**WATERVIEW RING ROUTE – WATERVIEW CONNECTION**

**GROUNDWATER AND GROUND SETTLEMENT CAUCUSING 26 January 2011, Facilitated by Murray Wallis, ERM NZ Ltd**

**Agreed Statement, 02 February 2011**

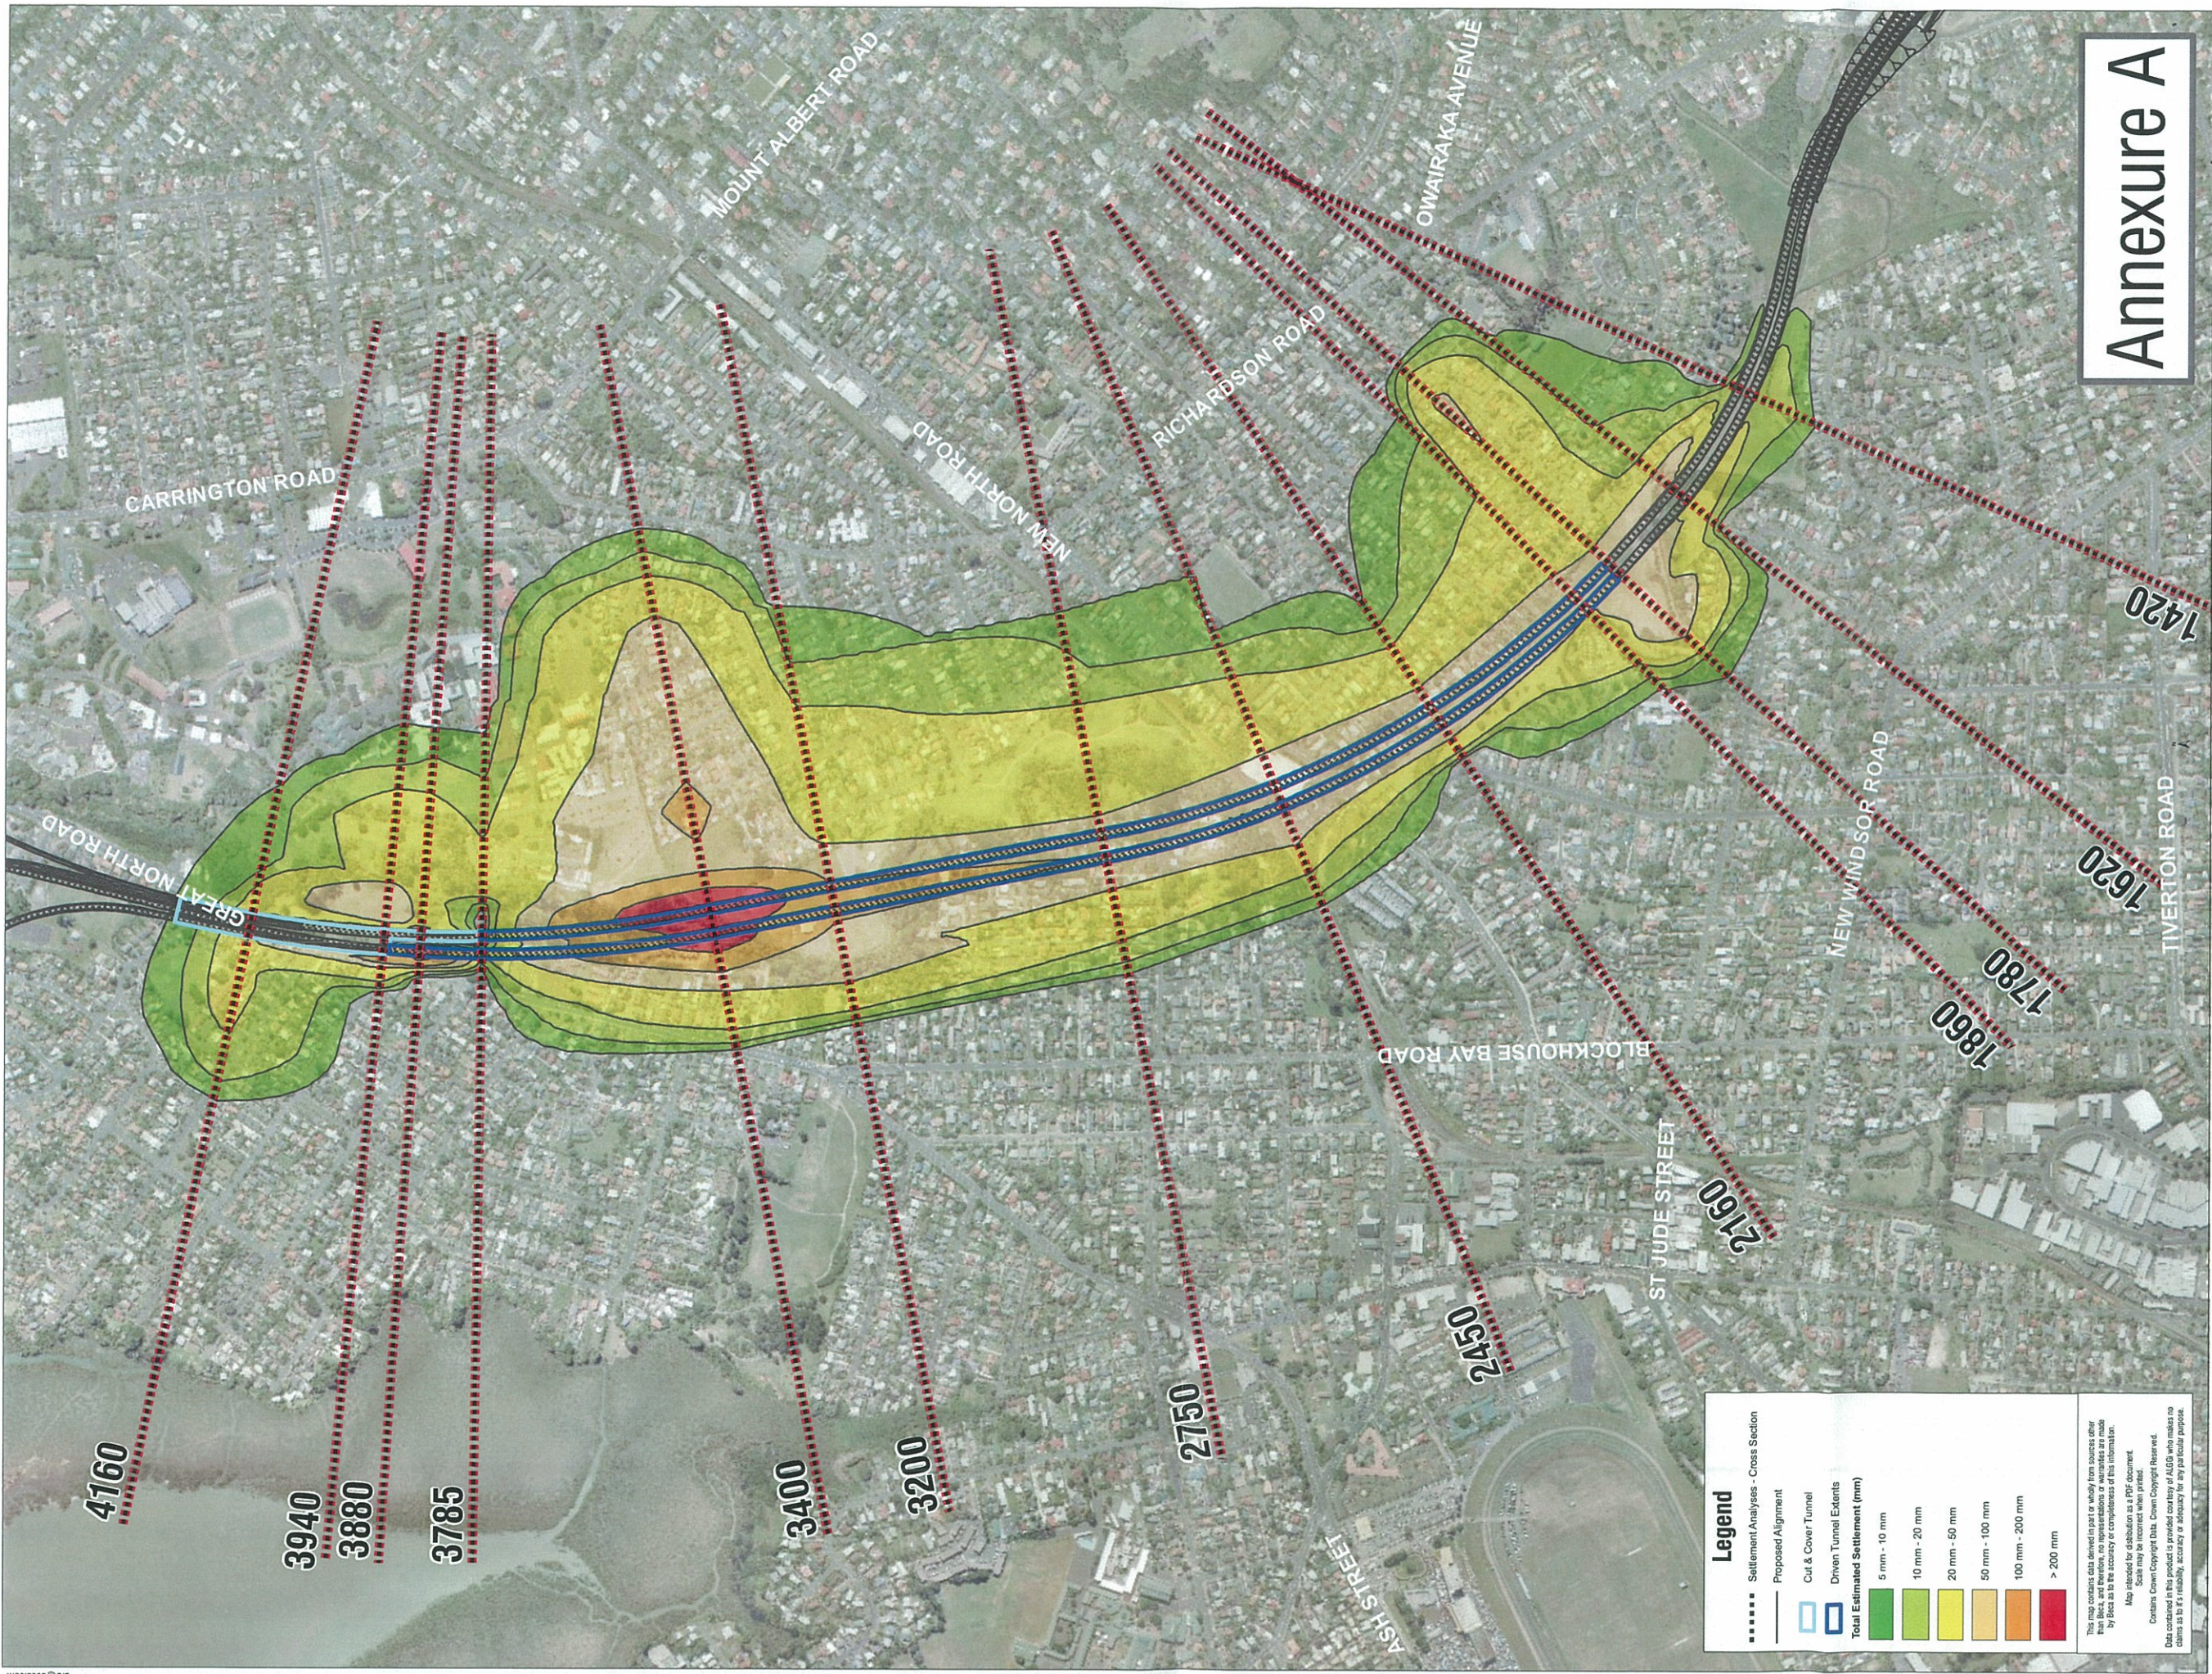
b. Provided the extent and magnitude of settlement does not exceed that identified in Figure E14 (updated figure attached to the rebuttal evidence of Gavin Alexander), then the difference in interpretation is of little consequence	Waitemata Group in the vicinity of Avondale Heights.

7. That the NZTA shall design and construct the tunnels and approaches as described in the Geotechnical Interpretative Report	Provided figure E14 (attached to the rebuttal evidence of Gavin Alexander) forms part of the Ground Settlement Conditions of Consent, then the proposed clause G.10 <sup>1</sup> is not needed		All

4. Settlement	<p>a. The experts agree to adding reference to Figure E14 (extended to include settlements beyond the northernmost and southernmost cross sections) to Condition S.1, and that new Condition G10 proposed by Earthtech can be deleted.</p> <p>b. The experts agree to add reference to Figures G1-G4 to Condition S.7 to define limiting building damage categories.</p> <p>c. The experts agree to nominating alert and alarm levels for settlement monitoring at 75% and 100% respectively of the values indicated on Figure E14, subject to incorporation of seasonal effects. Condition S.2 has been updated accordingly.</p> <p>d. The experts agree that the effects of settlement on the previously landfilled materials below the Council owned Phyllis Street, Harbutt and Alan Wood Reserves will be no more than minor.</p>		AW, GA, AN, PK, AS

<p><u>Differential Settlement</u></p>
<p>S.17</p>	<p><u>Pairs of settlement markers shall be established on each side of the cross sections identified on Figure E14 to monitor differential movements. The markers in each pair shall be no more than 20m apart, and each pair shall be within 100m of the centreline of the closest tunnel. Monitoring installed in accordance with Condition S.11 can be utilised for this purpose. Each pair of markers shall have alert and alarm values set based on the calculated differential settlements at that location and consistent with the relevant calculated Building Damage Category (Figures G1–G4). Alert and Alarm levels shall be as defined in Condition S.2. Monitoring frequency shall be as defined for Framework Markers in Condition S.3.</u></p>
